SPB Number: 2022.0101

EQUIPMENT UPDATES

Issued: 05/13/2022

STANDARD PLAN BULLETIN NOTICE
RaceTrac Engineering and Construction Division

- Sheet: A140
- Attachments: A140

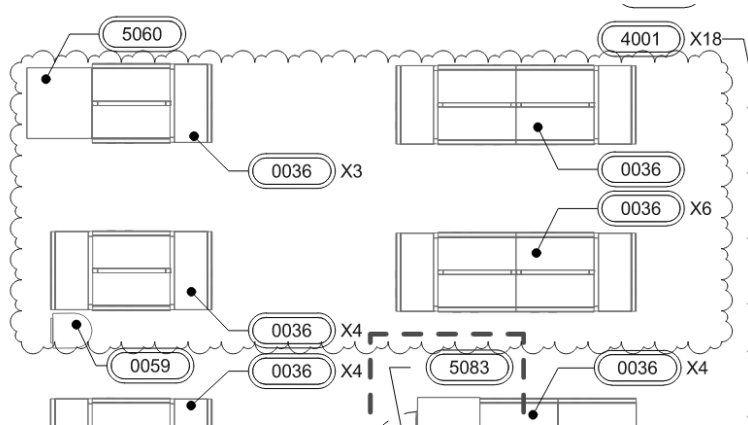
2. **GONDOLA UPDATE:** Relocated Floor Gondola and Shelving #0036 per the new layout.

- Sheets: A123, A141, A510 & A511
- Attachments: A123

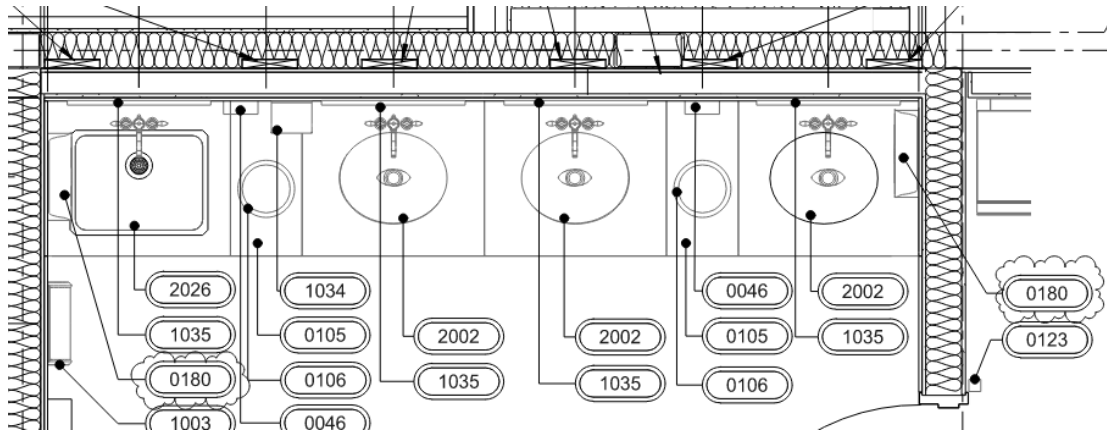
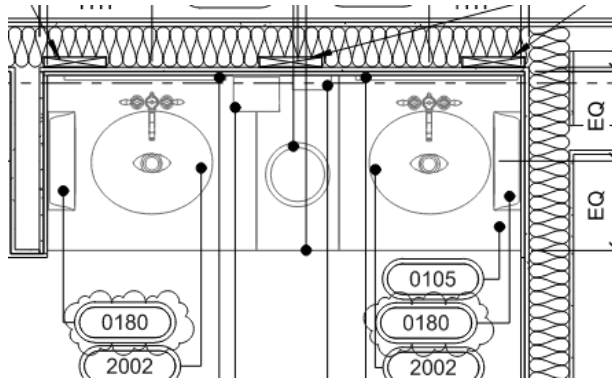
3. **HAND TOWEL DISPENSER:** Replaced Hand Towel Dispenser #0045 with #0180.

- Sheets: A140, A141, E002, E110 & E431
- Attachments: A140

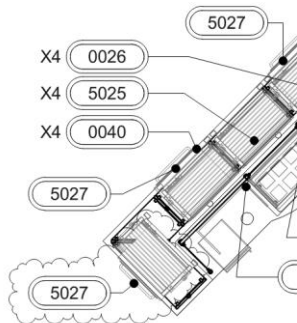
4. **BUN WARMER:** Added additional Bun Warmer #5027 at the Hot Dog Island.

- Sheet: C200
- Attachments: C200

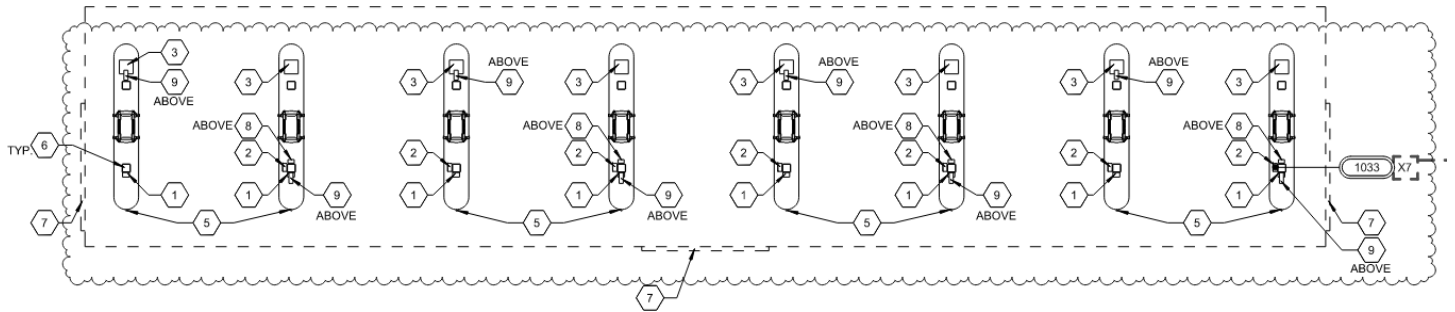
6. **EDO FUEL CANOPY SPEAKER:** Revised keynote #2 regarding hand towels. Added keynotes #8 and #9 for the fuel canopy speakers and hose reels. Revised EDO fuel canopy to include the curb, speakers, hose reels.

2	HAND TOWEL DISPENSER. SEE SHEET A141 FOR ADDITIONAL INFORMATION
3	TRASH CAN. REFER TO SITE PLANS.
5	WOODFORD Y-34 FREEZERLESS IOWA YARD HYDRANT
6	STEEL CANOPY COLUMN, PAINTED EP-1
7	RACETRAC LOGO; REFER TO SIGN PLAN
8	SPEAKER. INSTALL ON THE CANOPY COLUMN CLOSEST TO THE STORE AND MOUNTED 18"-24" BELOW THE DECKING.
9	HOSE REEL
